# Reliability Analysis Update

Transmission Expansion Advisory Committee  
April 2, 2024

## NJ SAA Project b3737.22

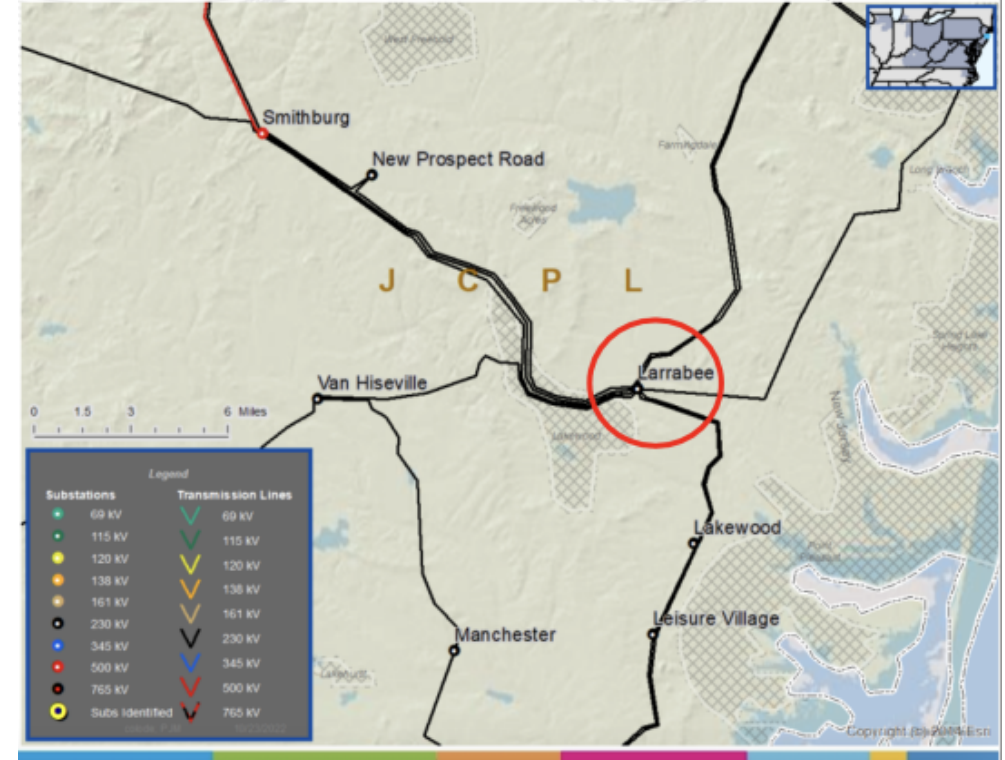
- Estimated Cost: \$216.3M
- Amended Scope for b3737.22:
  - Increase Sizing of Autotransformers: Increase sizing of four single phase 500/230 kV autotransformers at LCS from 450 MVA to 480 MVA to meet reactive power requirements

Estimated Cost Increase: \$800,000

Required IS Date: Remains 12/31/2027

NJBPU approved this modification in transformer sizing from 450 MVA to 480 MVA, by order issued on March 20, 2024, in Docket No. QO20100630.
